**From:** Seery, Scott, Env. Health  
**Sent:** Tuesday, May 06, 2003 4:15 PM  
**To:** 'aars@earthlink.net'  
**Subject:** RE: 800 San Pablo, Albany

**CITY OF BERKELEY**  
DEPARTMENT OF PUBLIC WORKS  
WASHINGTON/ADAMS RELIEF SEWER PROJECT  
PLAN AND PROFILE  
STATION 15+80(481.58M) TO 19+20(585.22M)

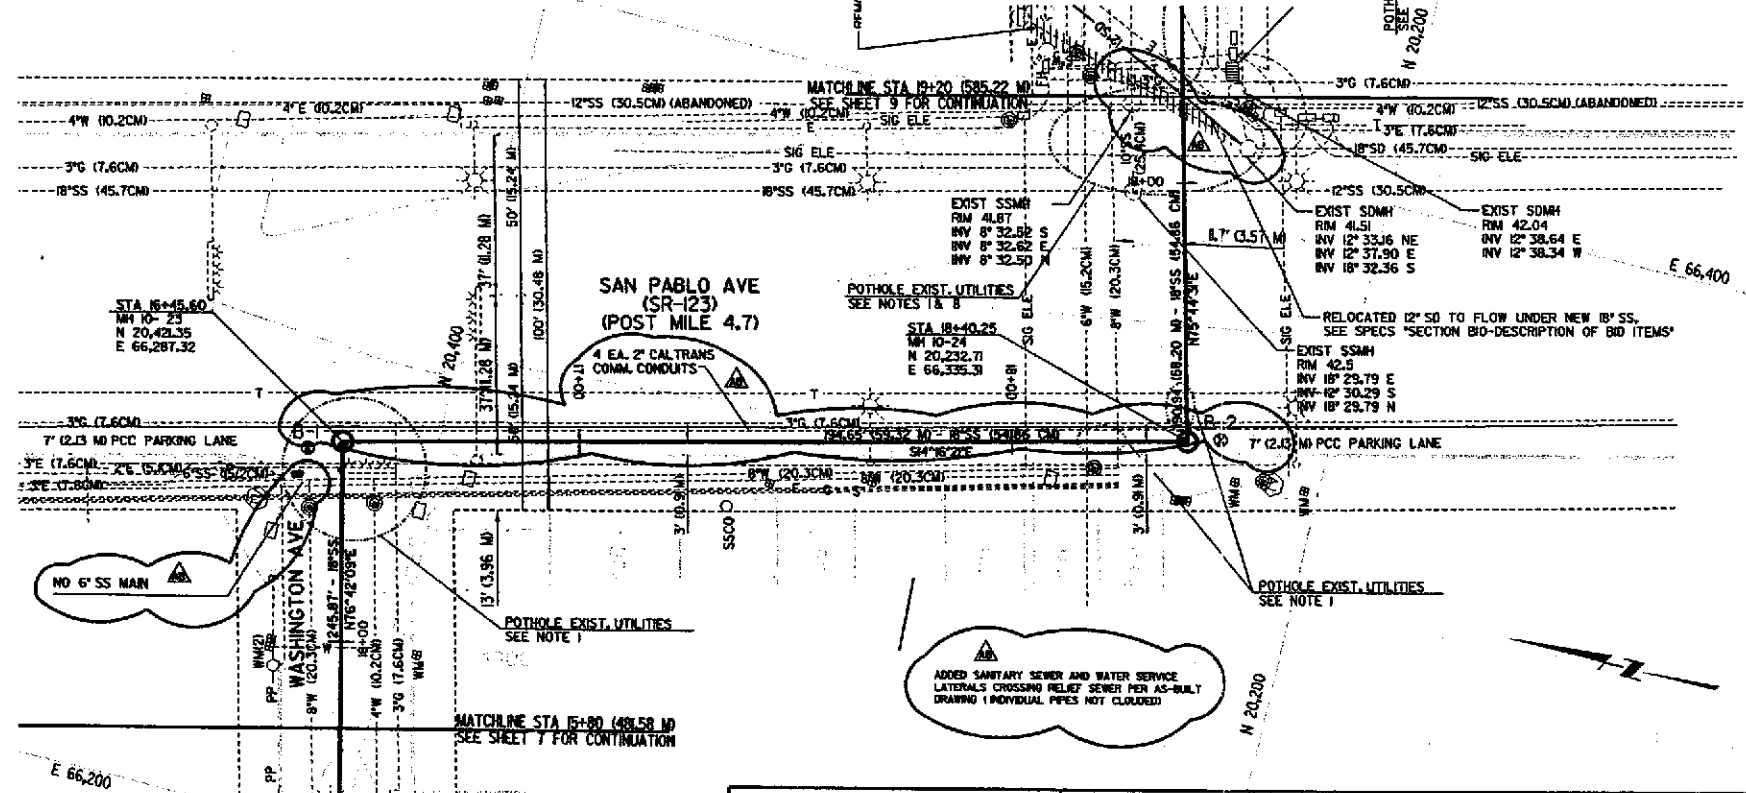
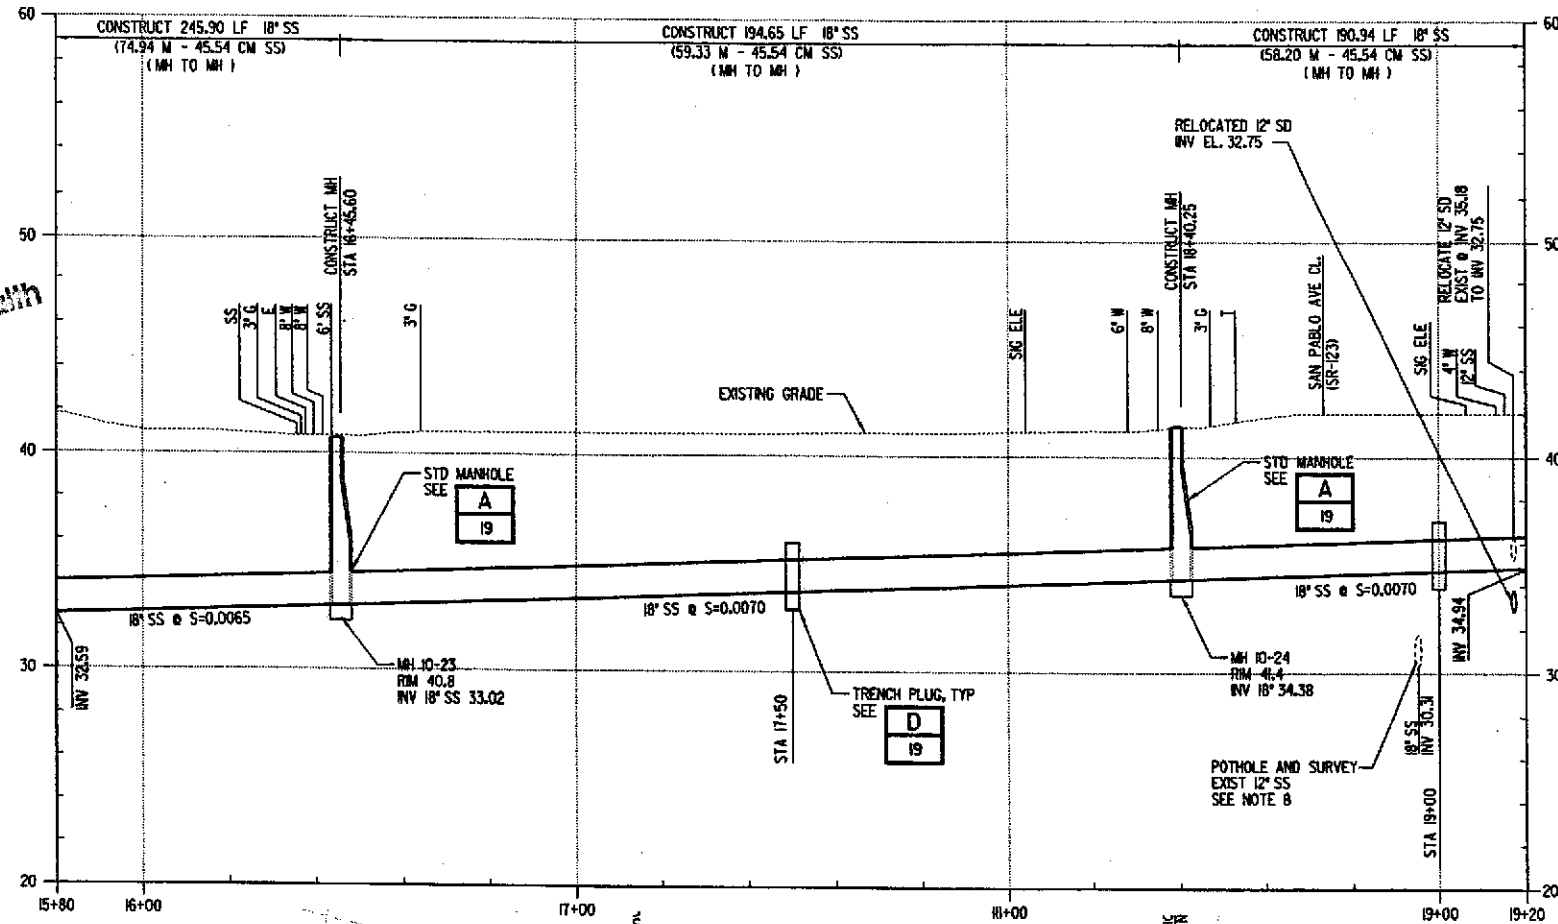
1) It appears that the Montgomery Watson map sheet depicts the Berkeley utilities.

There is no key or other explanation provided on the map, but I think I can interpret some of the elements, but not others.

Looks like an 18" sanitary sewer (SS), among numerous other utilities, passes in front of site.

I presume invert depths of the manholes (MH) and other landmarks are actually depicted in feet above MSL. For example, it appears that at the intersection of Washington and San Pablo, MH 10-23 has an invert elevation of 33.02'. Further down San Pablo, MH 10-24 appears to have an invert elevation of 34.38'

Please confirm these assumptions, and provide a key / explanation for symbols / abbreviations to aid review of these data.

Please confirm flow direction.

Please provide specific data for remaining buried utilities along San Pablo.

Please provide buried utility data for Washington Ave.
